# PARTS & SERVICE NEWS

REF NO. AA03032A

**SUBJECT:** REPAIR PROCEDURE FOR BRACKET ON RETURN HYDRAULIC PIPING

**PURPOSE:** To introduce modification procedure to repair cracks occurring in the hydraulic return pipe fastening bracket on WA800-3 and WA900-3 wheel loaders

### DETAIL OF MODIFICATION

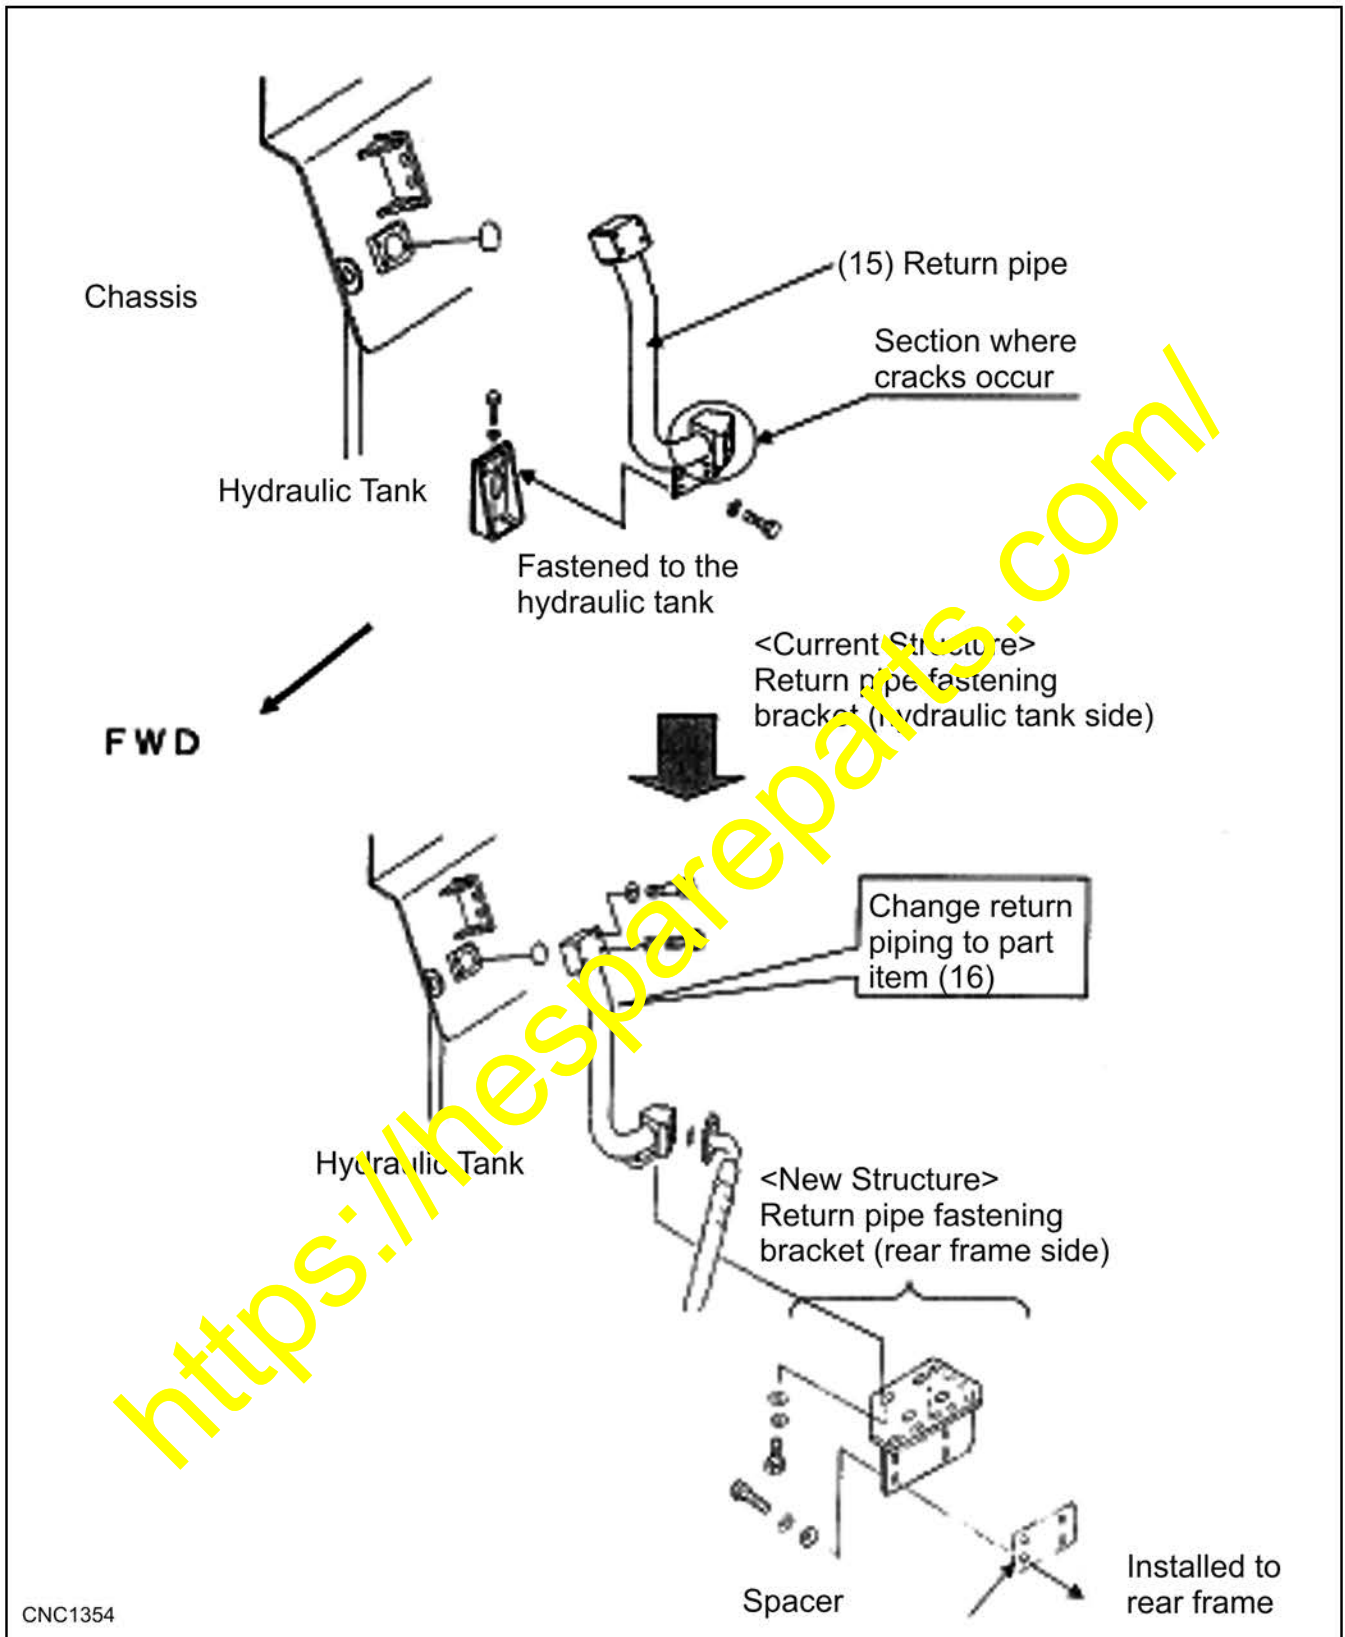
To change return piping mounting bracket to new part

### MODIFICATION PROCEDURE

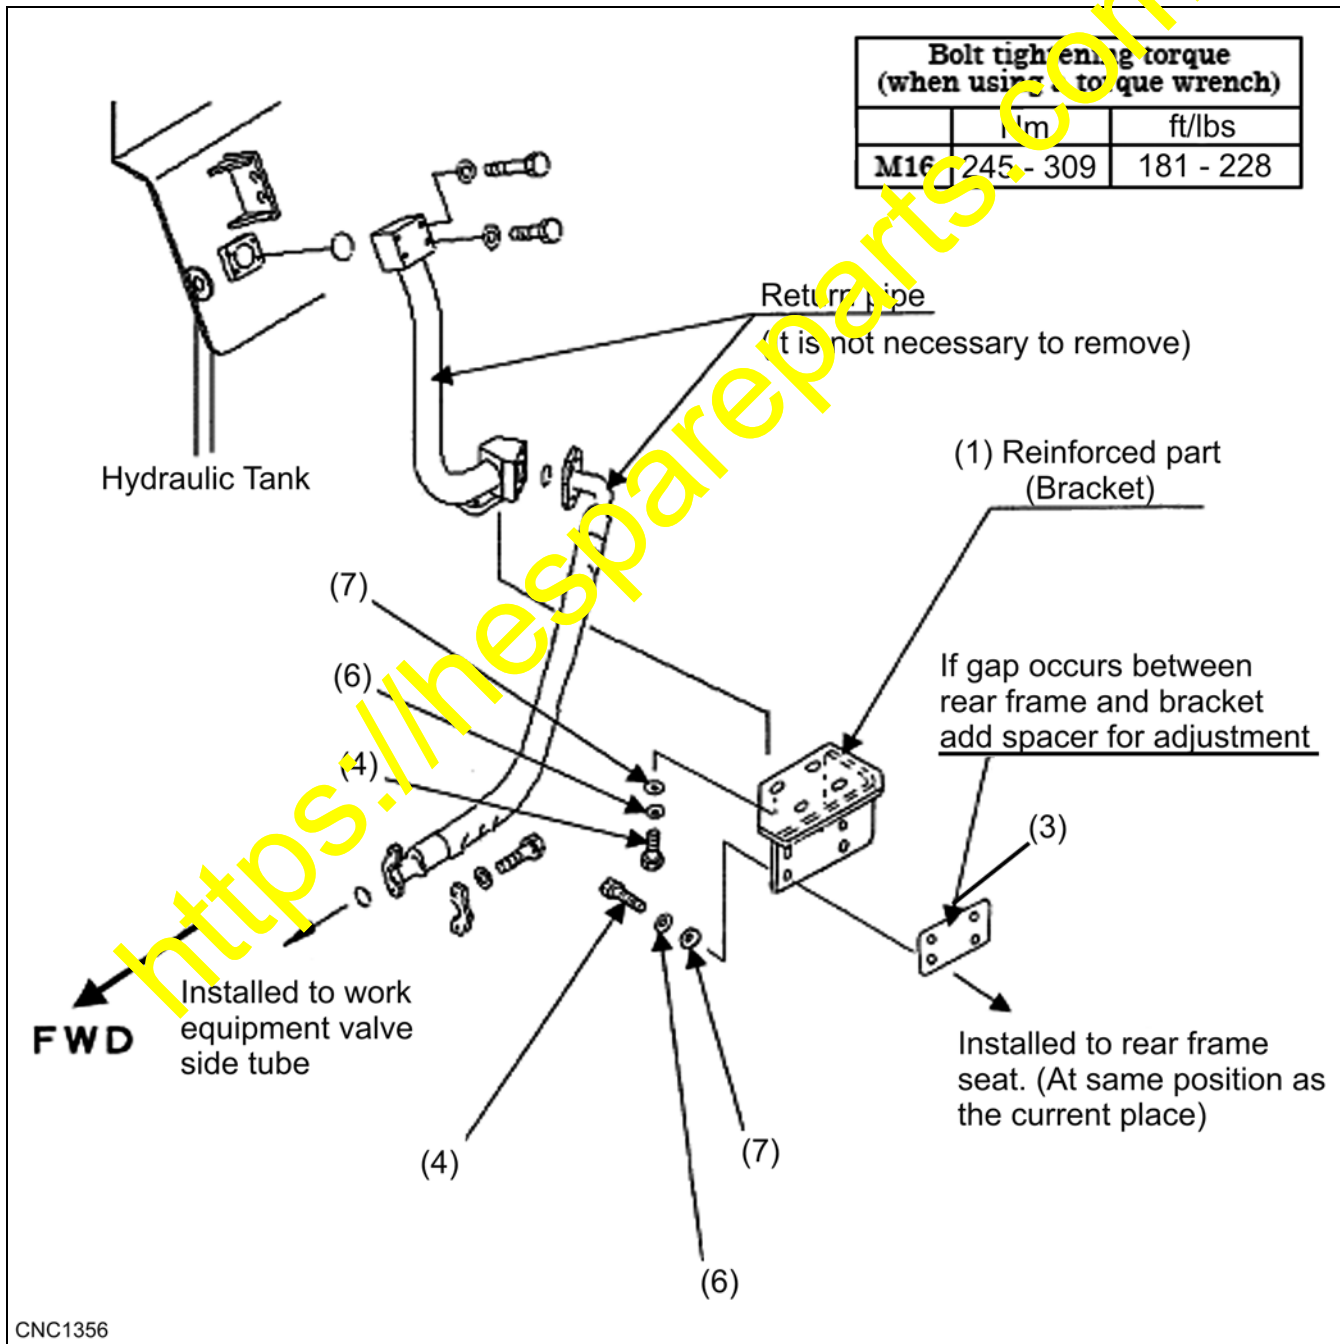
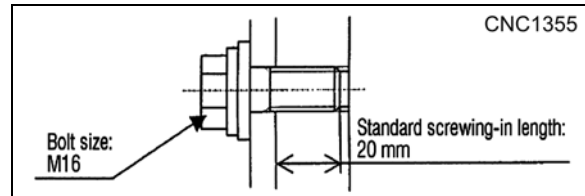
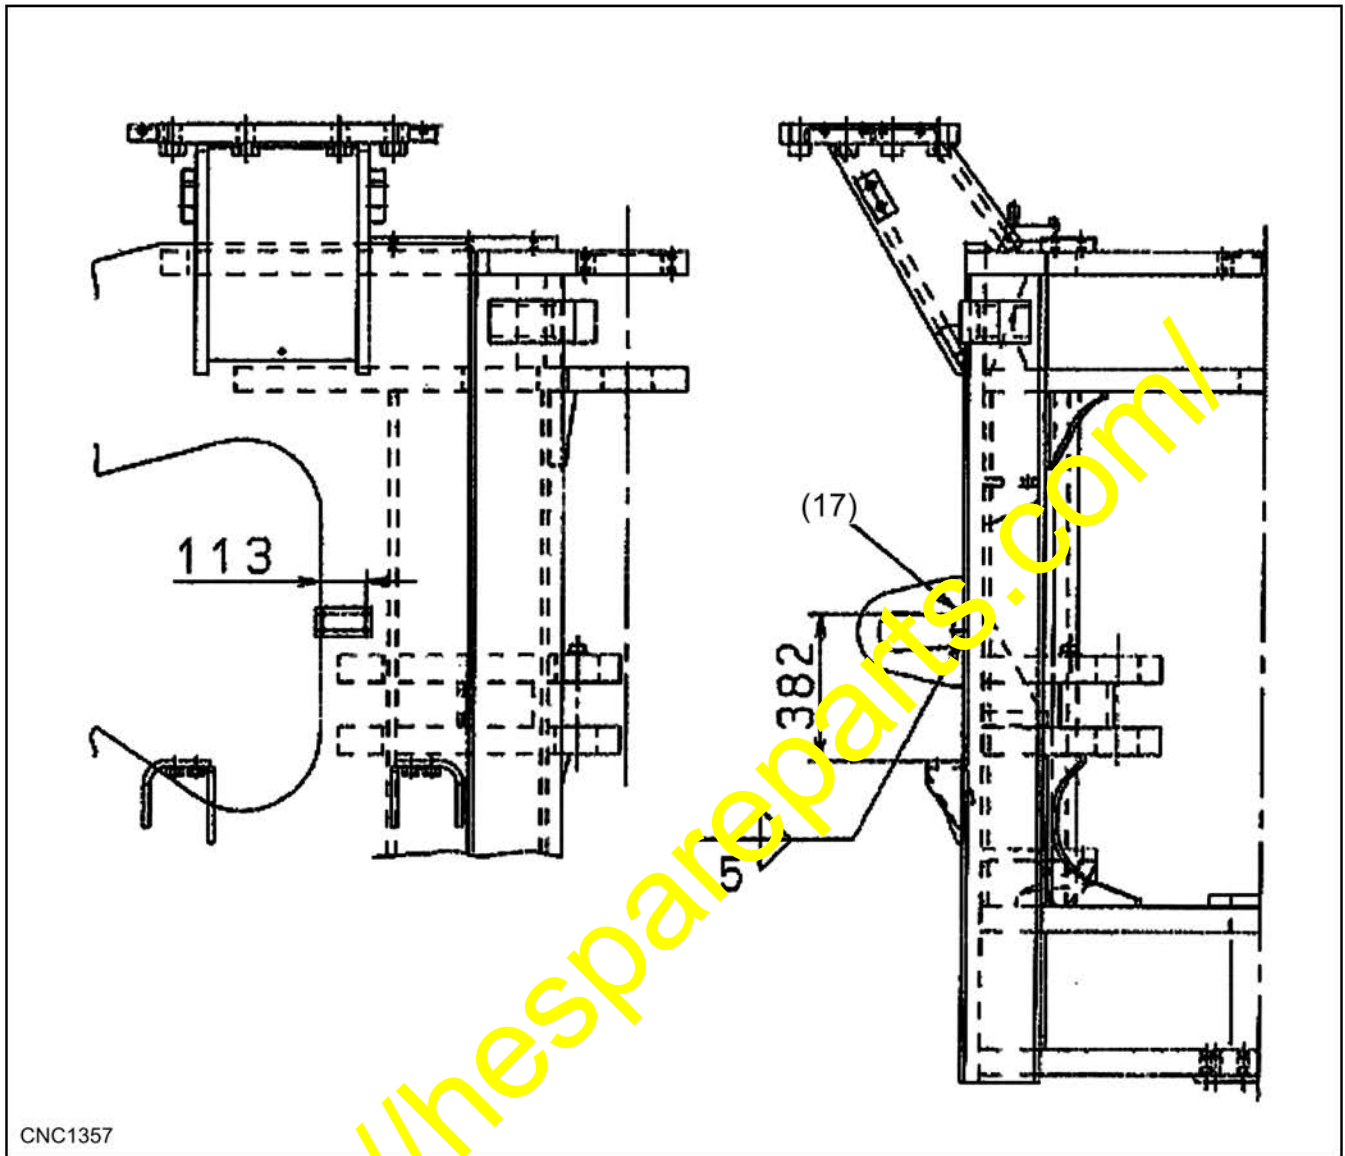
- Replace the current bracket to the new reinforced bracket as per the instructions given in the drawing below.
- When it becomes necessary to use a spacer on the mounting side to the rear frame, use spacer (427-62-25540). If the screw-in length of the bolts cannot be maintained at the standard length by addition of the spacer, change the bolts so screwing-in length may become the standard length indicated on the RH side. (These new bolts are being indicated on the list of parts.)
- Refer to the table on the RH side regarding the tightening torque for the bolts.

CNC1357

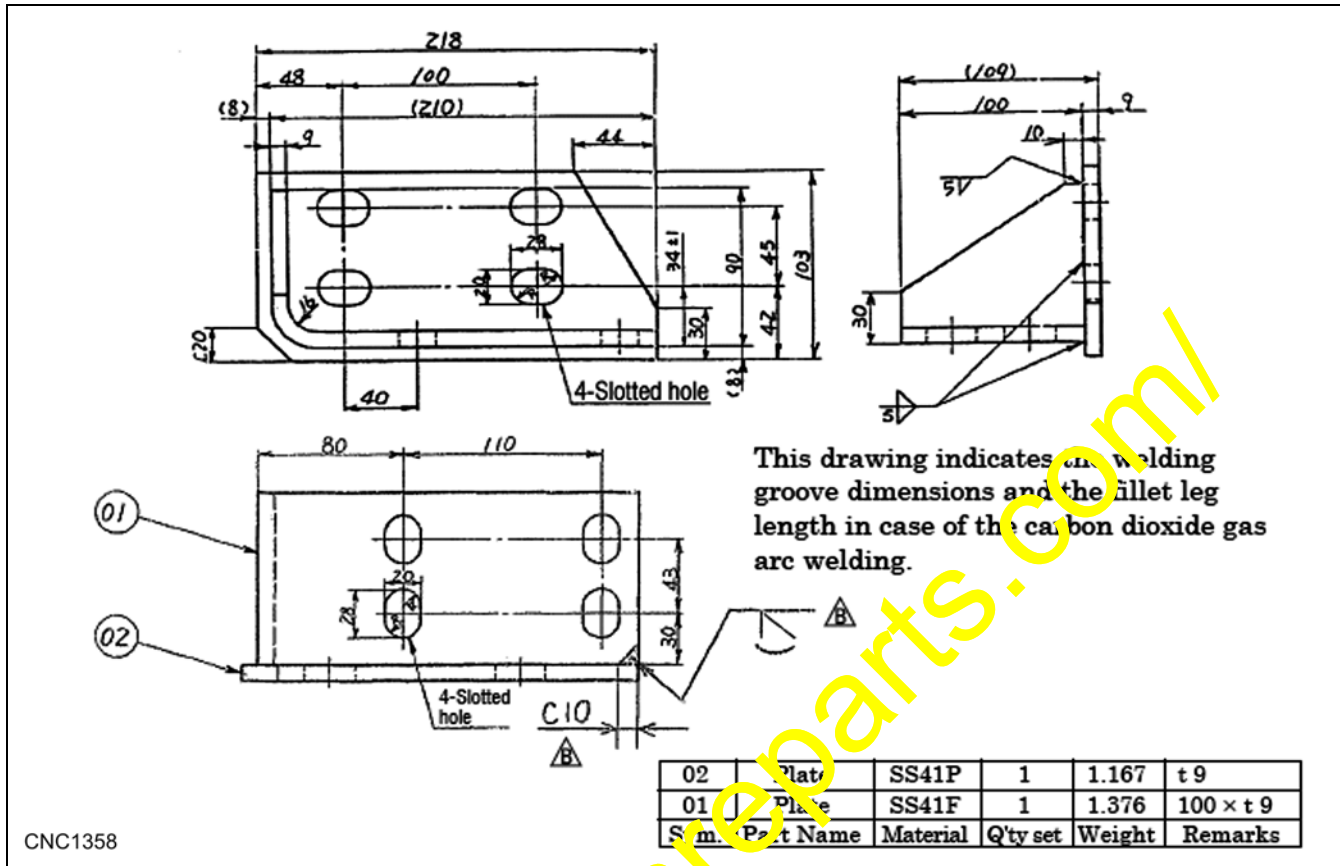
- Weld the seat to the right side of rear frame as shown in illustration below.

Part No. 427-62-25540  
 Part name: Spacer  
 Material: SS400F

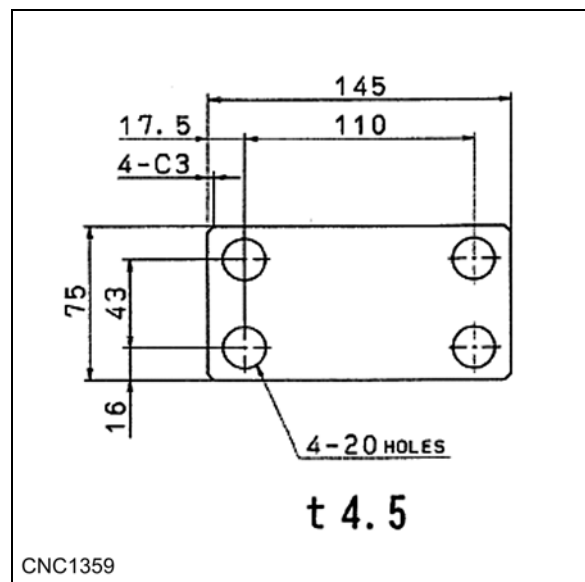
- Fabricate these parts according to the illustration below.
